Figure 1: Examples of (a) back-to-back grant and (b) hidden grant.

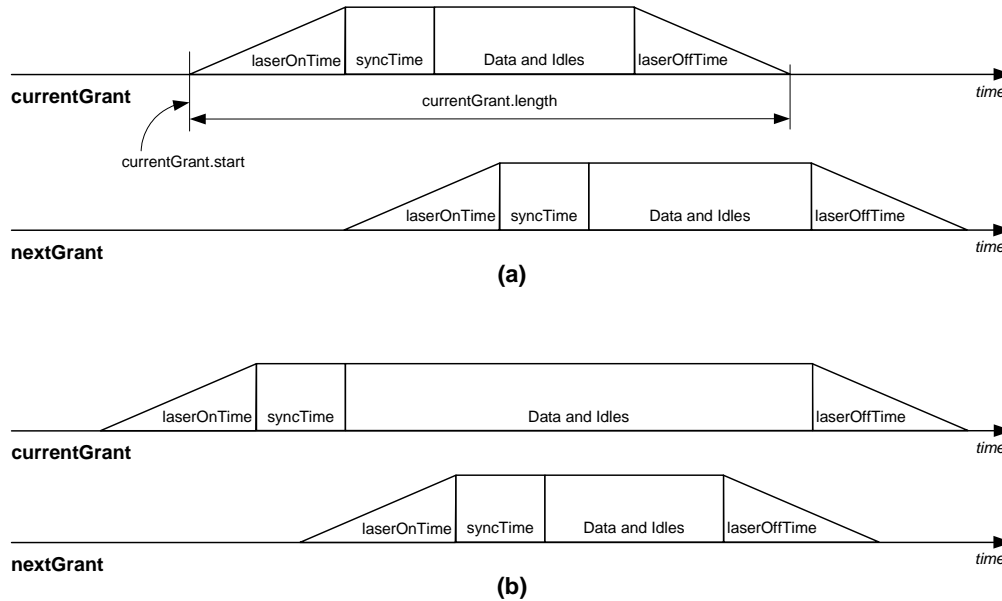
Please, note that, in the Gate Activation state diagram, the conditions for transitions from the CHECK NEXT GRANT state to states HIDDEN GRANT and BACK TO BACK GRANT are incorrect.

The transition to the HIDDEN GRANT state should be as follows:

The condition for transition to the BACK TO BACK GRANT state should be as follows:

In addition, the calculation of nextStopTime value is also incorrect, and should be changed to:

```
(nextStopTime ≤ stopTime) +
(nextGrant.start ≤ currentGrant.start + currentGrant.length) *
(nextGrant.discovery == true)
```

```
(nextGrant.start ≤ currentGrant.start + currentGrant.length) *
(nextStopTime > stopTime) *
(nextGrant.discovery == false)
```

```
nextStopTime = nextGrant.start + nextGrant.length - laserOnTime
               - laserOffTime - syncTime.
```
